UNITED STATES PATENT AND TRADEMARK OFFICE

APPLICATION NO.	FILING DATE	FIRST NAMED INVENTOR	ATTORNEY DOCKET NO.	CONFIRMATION NO.
10/567,087	02/03/2006	Katsuyuki Baba	Q93027	4612

Office Action Summary

DETAILED ACTION

Examiner's Appendix
(Bares et al. – US 5,127,484)

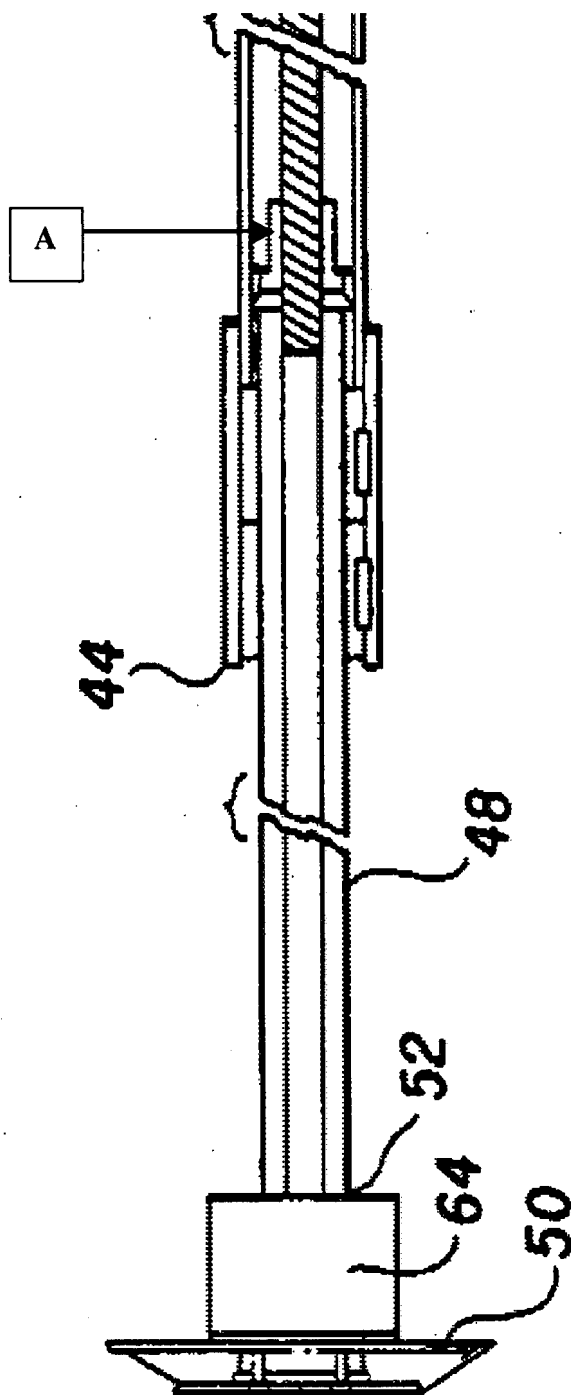
Bares discloses:

a linear motion link device (Fig. 4) with a motor (60), which telescopes in a longitudinal direction (col. 3, ln. 6-8).

A male screw shaft (62) fixed to the rotary shaft of the motor

A female screw nut (A in Examiner's Appendix) engaged with the male screw shaft, and

An inner rod portion (48) fixed to the female screw, sliding in the longitudinal direction.

Bares does not directly disclose a holding brake for the motor. Saisaka discloses a holding brake (**B**), which operates when the motor (**M**) is stopped. Therefore, it would have been obvious to a person having ordinary skill in the art at the time of the invention to modify Bares as taught by Saisaka in order to hold the leg in position when it is not being moved by the motor, while simultaneously saving electric power.
